APPLICATION FOR PERMIT TO DRILL OR REENTER

*Please refer to approved NOI appended to this application for the most recent changes to the design for this proposed well.

8. Lease Name and Well No.: WILD WEASEL 22 FED COM ~~106H~~ New #754H

WILD WEASEL 22 FED COM 754H

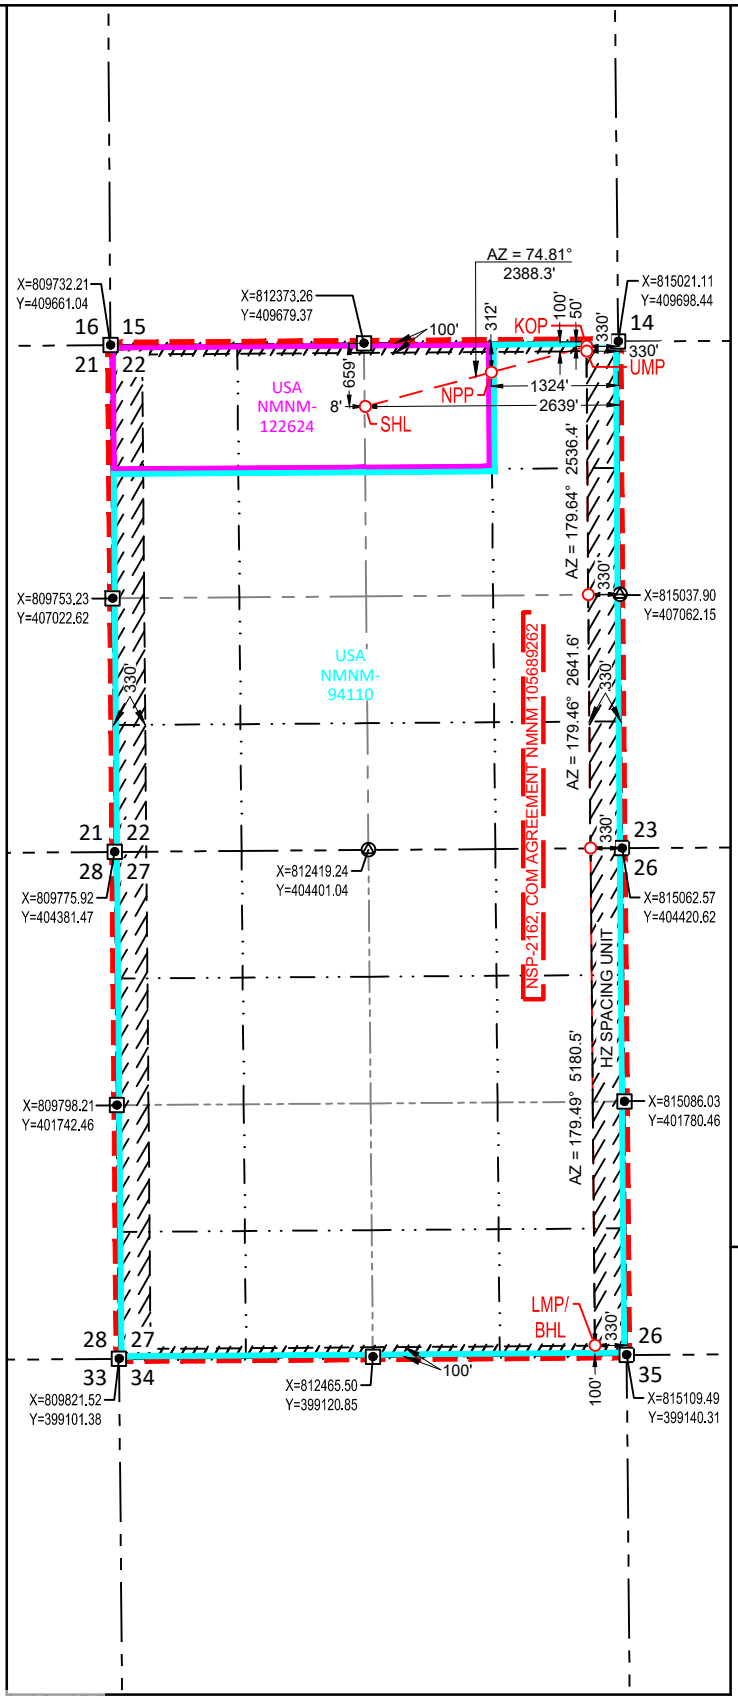
10. Field and Pool, or Exploratory: ~~RED HILLS/UPPER BONE SPRING SHA~~ PITCHFORK RANCH;WOLFCAMP, SOUTH

At surface: ~~659 FNL & 2639 FEL~~ ~~TR D / 305 FNL / 755 FWL / LAT 32.122428 / LONG -103.4639245~~

17. Spacing Unit dedicated to this well: ~~640.0~~ 1280
